MEMORANDUM FOR: John A. Olshinski, Chief
Operating Reactors Assessment Branch
Division of Licensing

SUBJECT: Review of a Draft on Snubber's Technical Specification
Visual Inspection for La Salle

At the LaSalle Technical Specification Meeting of July 16, 1981 information pertaining to the snubber section of the Tech Specs was requested. The items listed as Attachment 1, Figure 4.7.1, Figure 2, and Figure 3 of this telecopy provide our derivation of the Wald Sequential Sampling Plan, and our justification for the elimination of the rejection line. Also included are comments pertaining to the Table of visual inspections in 4.7.9. a of the Tech Specs, which includes our derivation of an alternate inspection table.

Figure 4.71

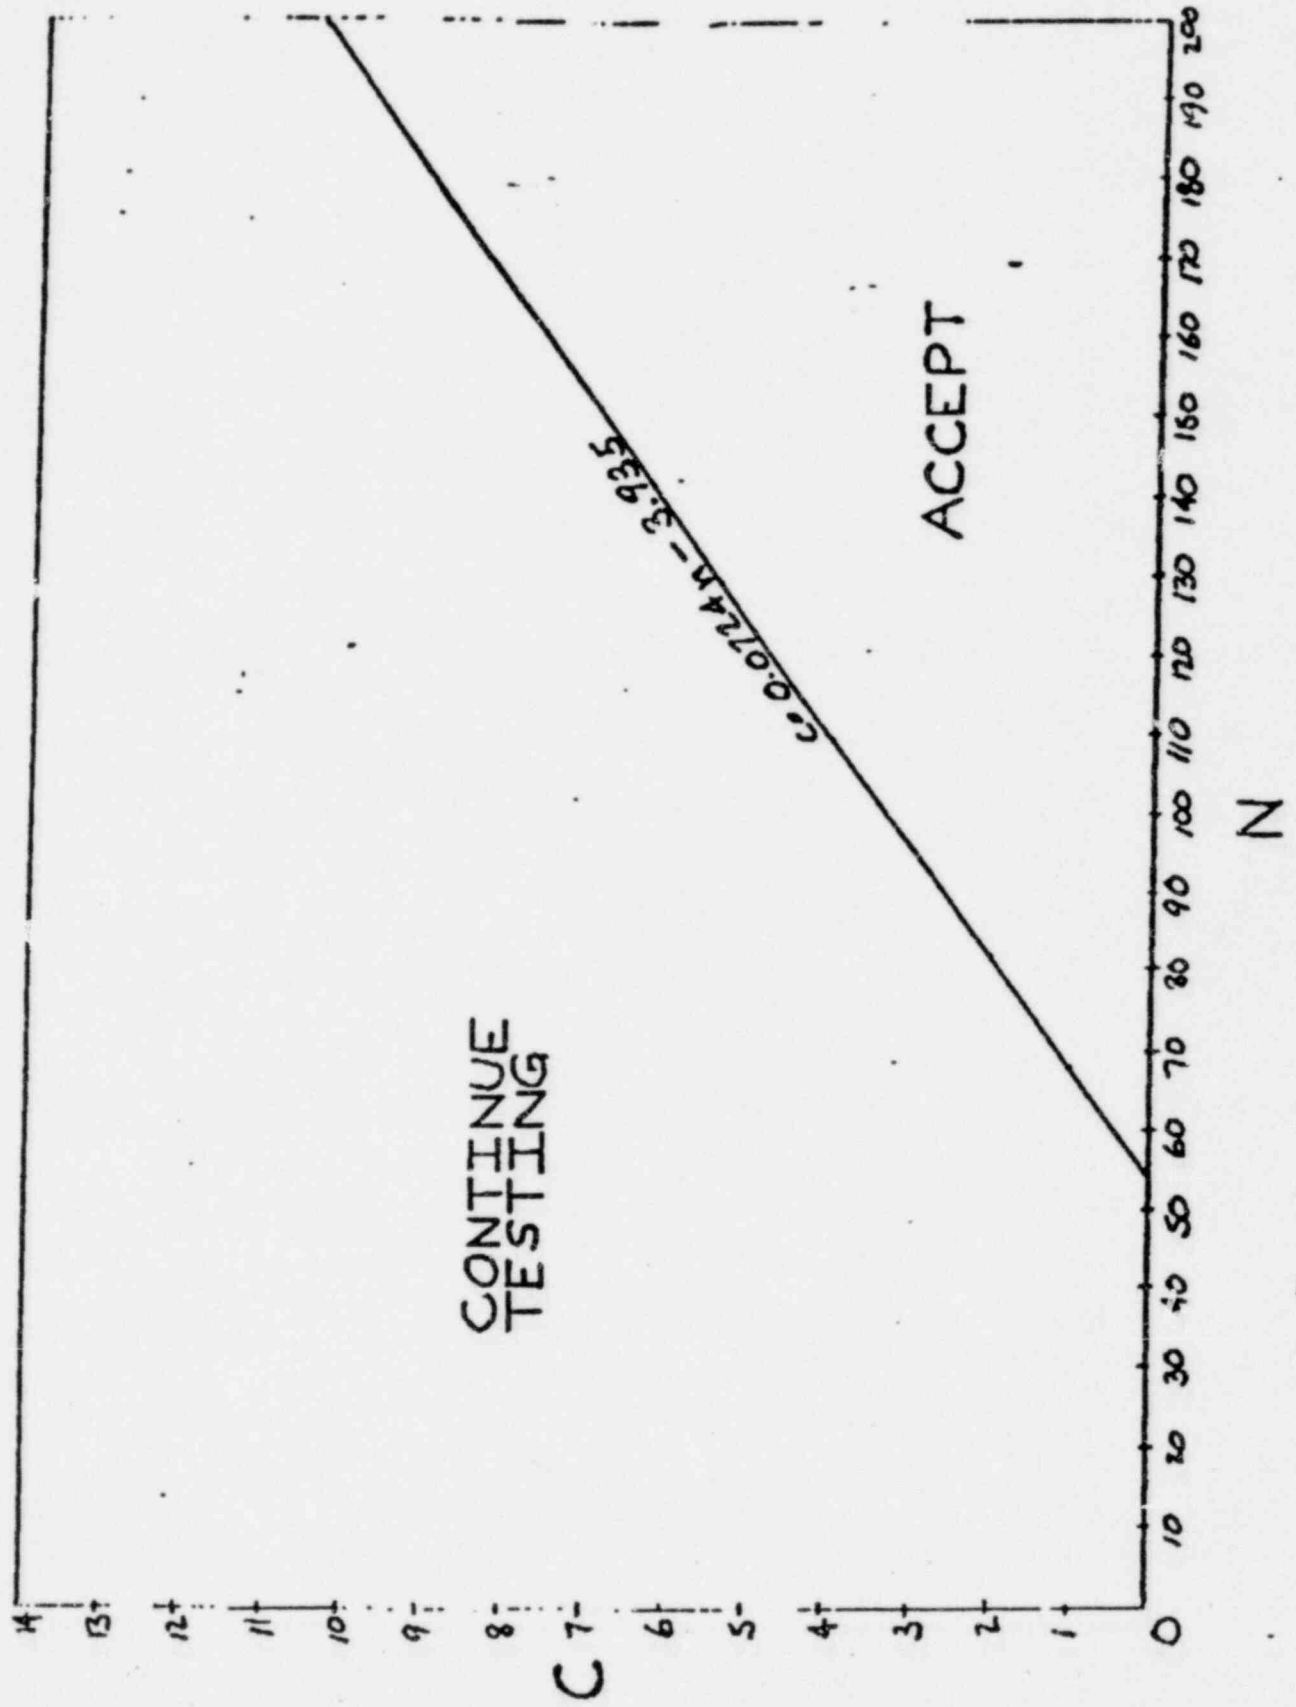
$a_n = 0$ at $n = 55$, thus at least 55 snubbers must be tested before testing can cease. The specific number of snubbers, n , which would have to be tested before testing could cease can be calculated by assuming a_n is the number of failures and solving the equation ($a_n = .0724n - 3.935$) for n . This can be shown on a graph, as shown in Figure 4.7.1.

On Figure 4.7.1, "C" is the total number of snubbers not meeting the acceptance criteria. The cumulative number tested is denoted by "N". As the testing continues, the values of "C" and "N" may be plotted. Whenever a point plotted falls in the "ACCEPT" region, testing is terminated. When the point plotted lies in the "Continue Testing" region, additional snubbers are tested with the objective of getting into the "Accept" region. It can be seen that the equation $a_n = .0724n - 3.935$ determines the end of the continue test and the start of the acceptance range.

It is felt that the Rejection line can be eliminated on the bases that an unacceptable snubber population would be detected thru the requirement to cross the acceptance line, and that the probability of a random variance from the reject to the acceptance region is extremely low. The Tech Specs state that the desired confidence level is approximately 95%. It is felt that a 0.11537 percent decrease in the confidence level does not jeopardize the health and safety of the public. LaSalle proposes to use the Wald Sequential Sampling Plan as provided in Figure 4.7.1.

Figure 2

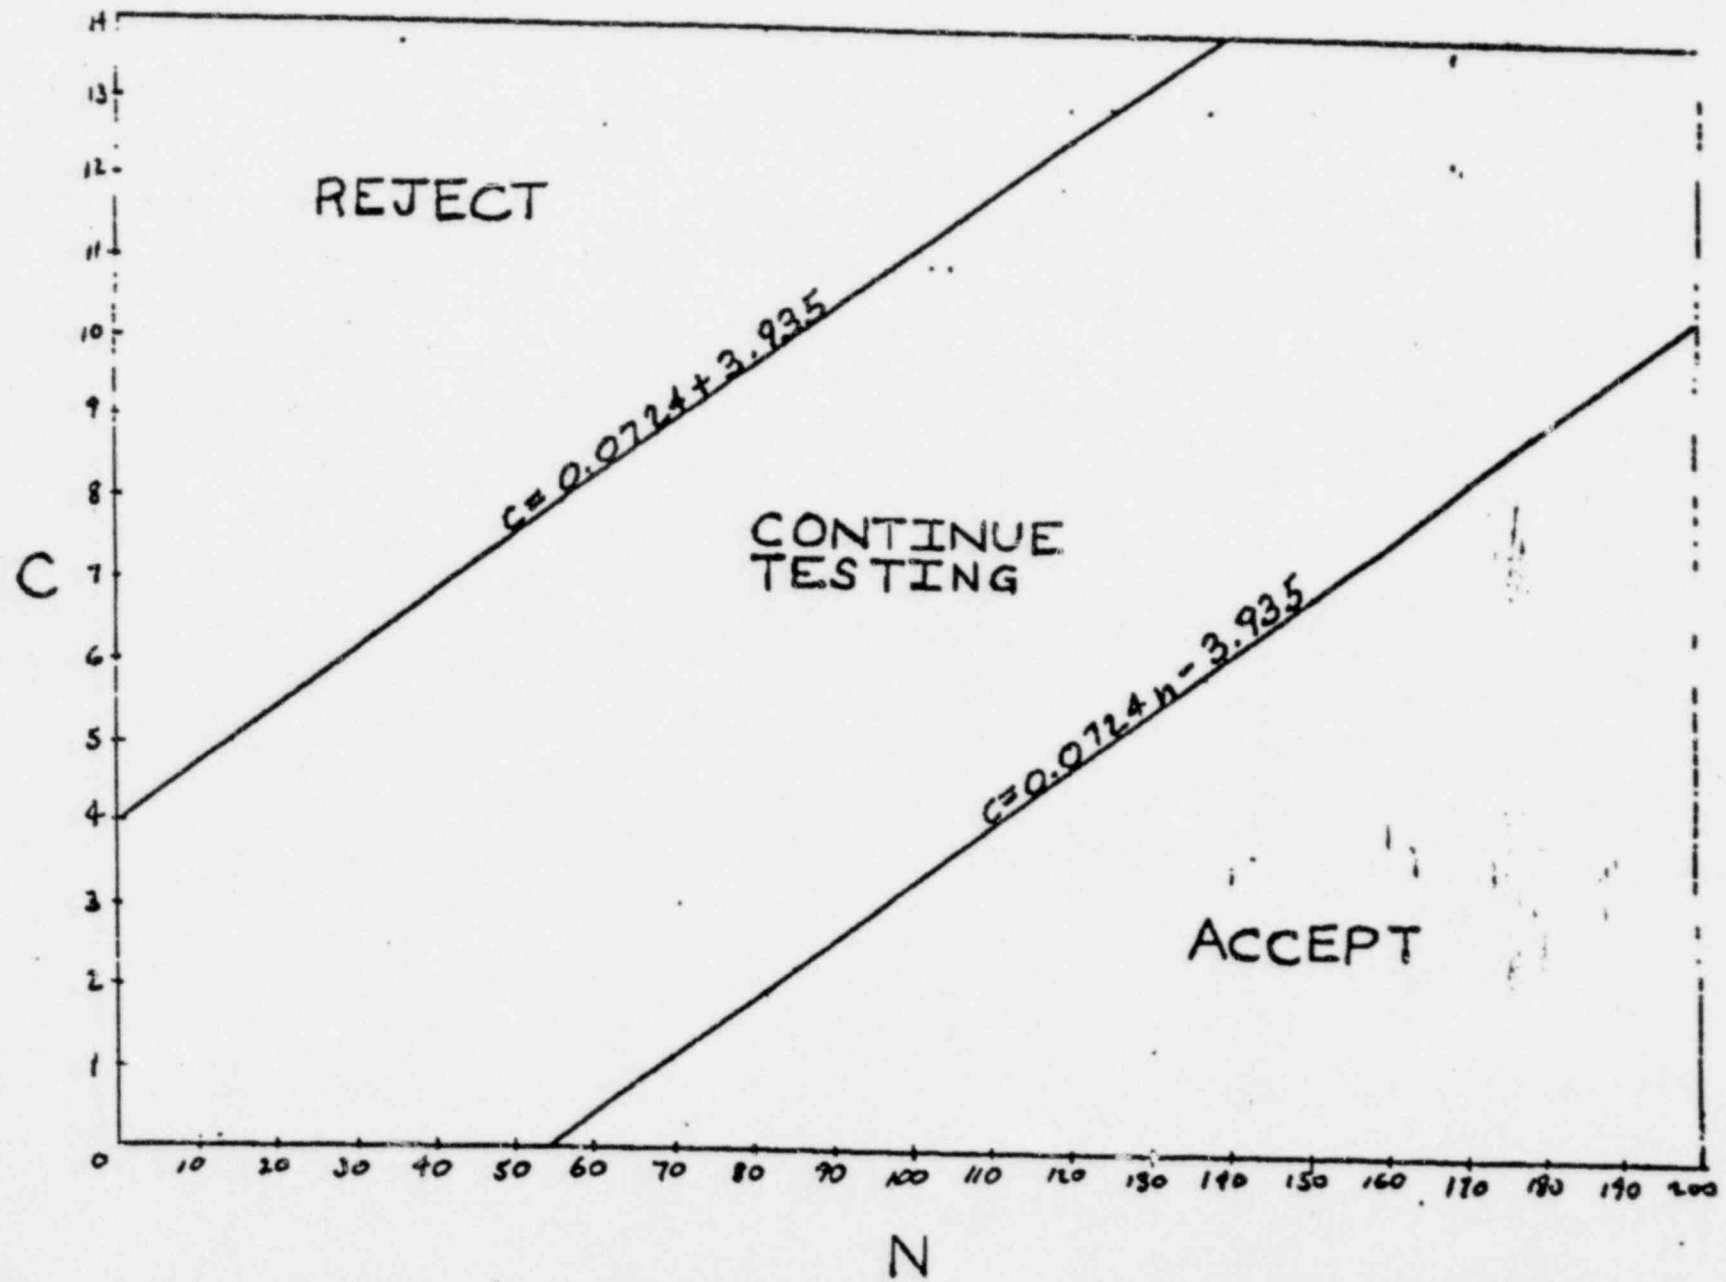
Figure 2 illustrates both the acceptance and rejection lines.

LaSalle County Station is committed to testing (and repairing) all snubbers in a group if the functional testing does not demonstrate an acceptable fraction of defectives. In light of this commitment, the use of a rejection line provides no benefit. On the other hand, erroneously testing an entire snubber group with an acceptable fraction of defectives has significant consequences in plant availability and personnel radiation exposure. These consequences can be eliminated by eliminating the rejection line. The risk of erroneously testing an acceptable snubber group is thus reduced to zero; for the LaSalle method the increased risk of accepting an unacceptable snubber group is extremely low.

Figure 2

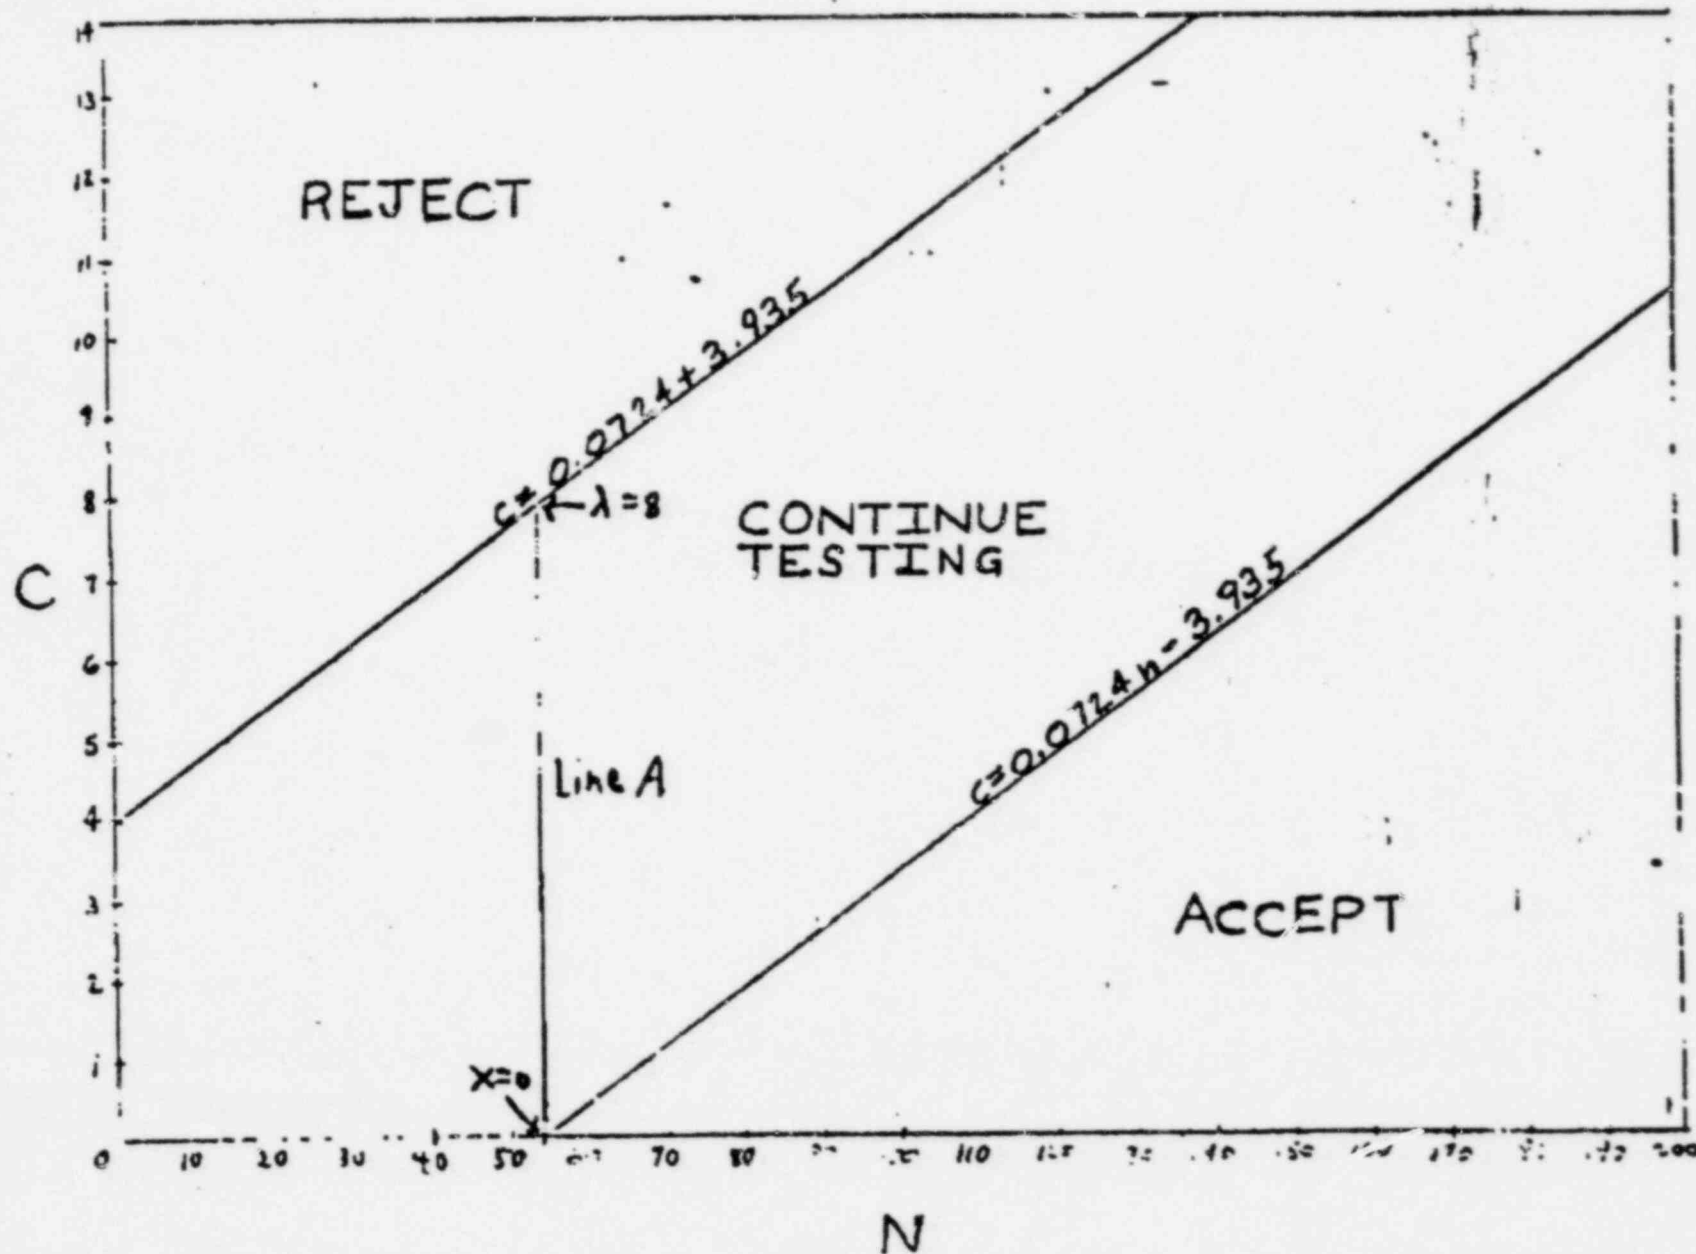
The Poisson distribution can be figured by taking any point on the rejection line along with the corresponding value on the acceptance line. The point selected was where the number of failures is "0" on the acceptance line, which corresponds to "8" on the rejection line, see Figure 3. At this particular point on the graph (Figure 3), it requires 8 or more failures to be in the "Reject" area. Thus λ values for 8 and above must be used in the above formula for the Poisson Distribution. The point on the acceptance line is always "0", thus $x = 0$ in the above formula. With these values of x and λ , the Poisson Distribution formula becomes:
